# Buffalo River Watershed Alliance Comments on C&H Reg 5 Permit Denial

Position Summary	2
Part A - Permit risk	3
Part B - Application Fields	7
Part C - Geologic and Engineering Site Investigation	29
Part D - Degradation	62
Part E - Miscellaneous	69
<b>Part F - <i>Additional Comments added for recent proposed denial</i></b>	<b>93</b>

## Comments on C&H Reg 5 Permit Denial

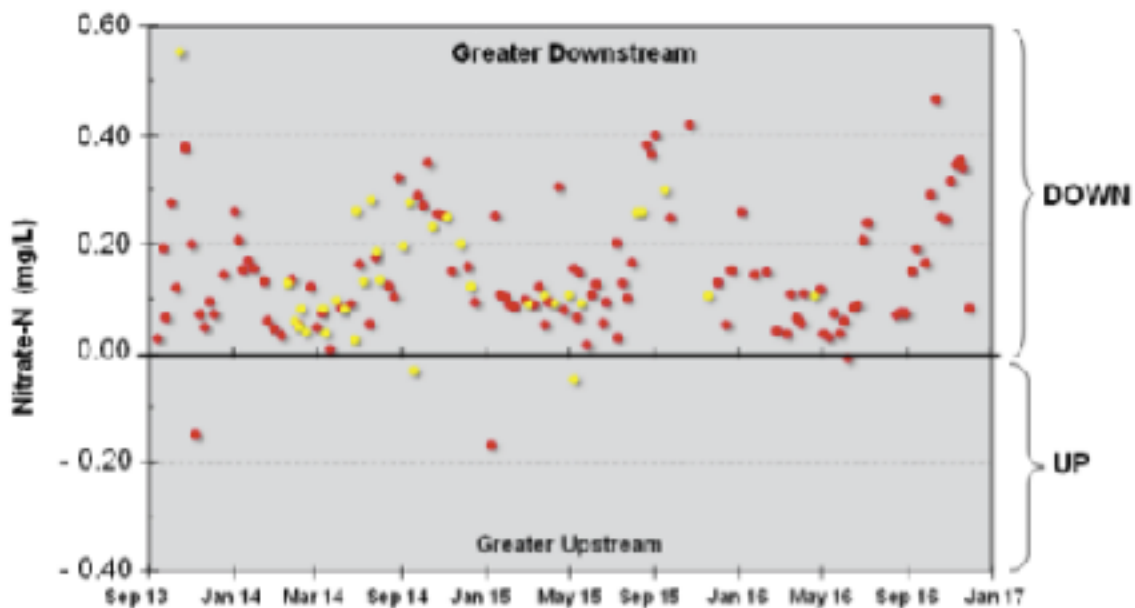
Nitrates are being measured by the *Big Creek Research and Extension Team* (BCRET) of the *University of Arkansas Division of Agriculture* both upstream and downstream of the facility and nearby spreading fields Figure 1.

***“Nitrate concentrations at the downstream site have been consistently higher than at the upstream site on nearly all BCRET sampling dates since swine waste applications from the C&H CAFO began (BCRET 2014a-d, 2015a-d, 2016a-d) (Figure 1). During January – November 2016, for example, paired upstream/downstream data showed that nitrate was substantially lower at the upstream station than at the downstream station on 40 of 41 sampling dates; concentrations were comparable on the remaining one date. Elevated nitrate levels near swine CAFOs are commonly used as an indicator of swine waste discharge; the wastes initially are high in ammonia, but over short distances during transport the ammonia is oxidized to nitrate (Dewi et al. 1994). Nitrate***

Figure 3: Dissolved Oxygen data for Big Creek (BUFT06) during August of 2015. (Source USGS)

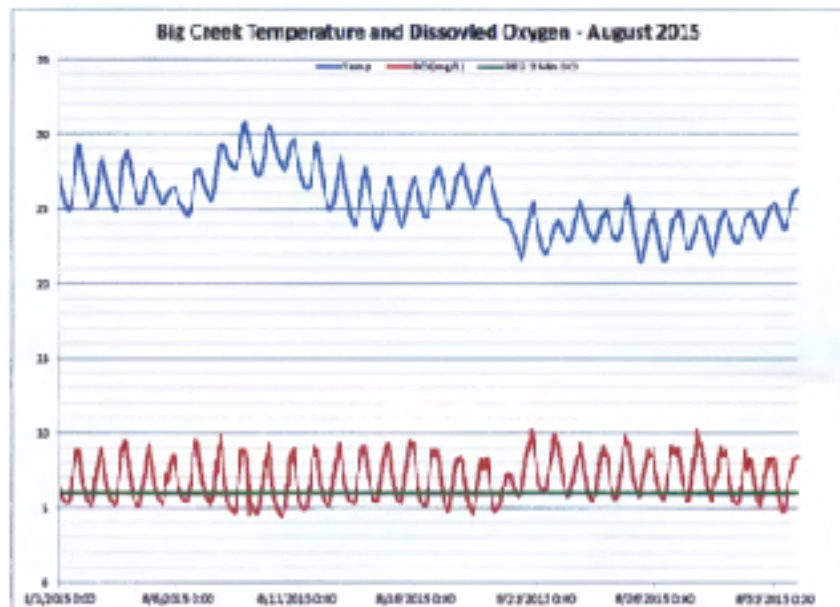
***“NPS has also been monitoring the United States Geological Survey (USGS) sites collecting dissolved oxygen data on tributaries to the Buffalo River. Two of these sites have chronically been below the allowable limits in Regulation 2.505. These are Bear Creek near Silver Hill (USGS Site 07056515) (ADEQ site- BUFT12) (Figure 2) and Big Creek at Carver (USGS Site 07055814) (ADEQ site- BUFT06) (Figure 3). These streams have had minimum dissolved oxygen values of 3.9 and 4.5 mg/L, respectively, well below the standards.”***

***“As dissolved oxygen is very important for aquatic life, particularly for species such as freshwater mussels, and such species are part of the suite of scenic and scientific resources Congress expected to be conserved when the Buffalo National River was established, NPS needs the assistance of ADEQ in determining the sources of low dissolved oxygen and reducing or eliminating these sources. We feel that both of these streams should be placed on the “Impaired Waterbodies” list pursuant to Section 303(d) of the Clean Water Act.”***
